# 1956 Corvette Service Bulletin: Clutch Disc - Springs - Periodic Vibration

**Subject:** Clutch Disc - Springs - Periodic Vibration

**Model and Year:** 1956 Passenger Car and Truck

**Bulletin No:** DR #266

Figure 1  
1956 CLUTCH IDENTIFICATION

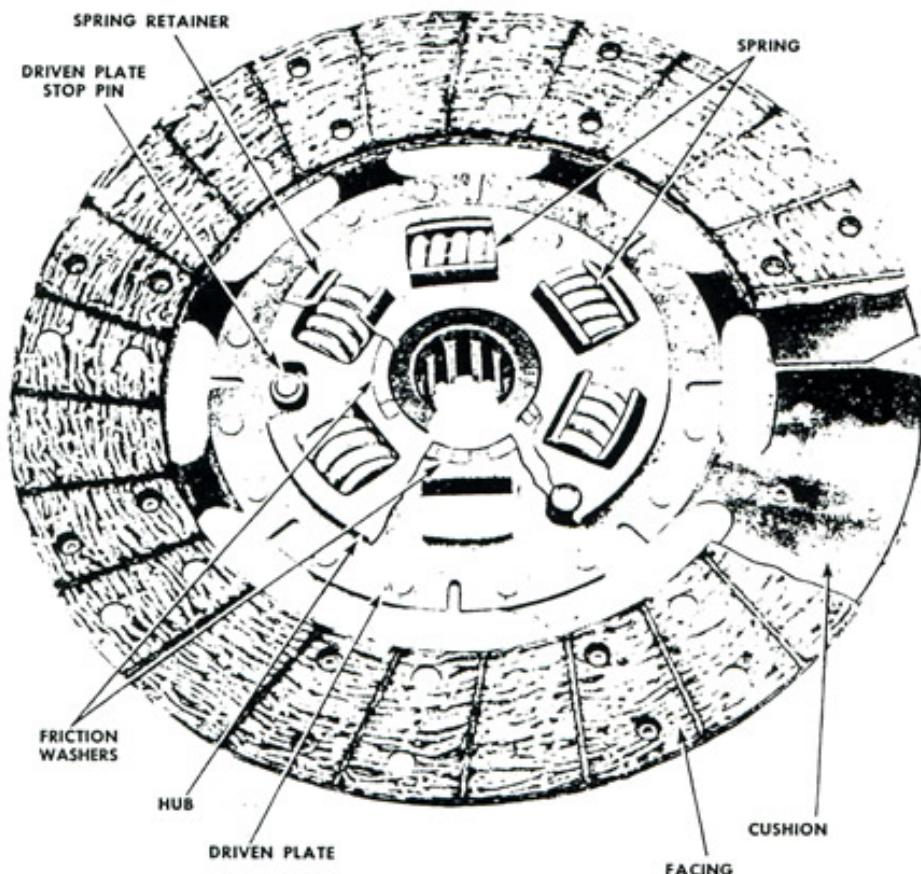
To control periodic vibration as outlined above, dampers are incorporated in the clutch disc assemblies, Figure 1 on page 2 shows cutout illustration of the construction of a clutch disc assembly. The number of coil springs, size, and other details, will vary in some discs; however, this is a typical example.

One-piece friction washers are also installed on both sides of the driven plate hub. These create friction between the moving parts of the assembly, this friction is predetermined and is maintained in production to make the assembly function properly.

It is important to keep transmission lubricant or any other lubricant out to prevent any variation in friction which will change the tuning characteristics of the assembly and permit periodic vibration.

IMPORTANT that the clutch disc assembly be replaced using a new clutch disc as listed in the chart for that particular model. Make sure there is no grease on the new clutch disc hub and dampers or the transmission main drive gear splines. If grease is present on the splines, the main drive gear bearing retainer should be corrected as necessary.

Unit should be drive at least 25 miles to stabilize friction lag in the new clutch disc.
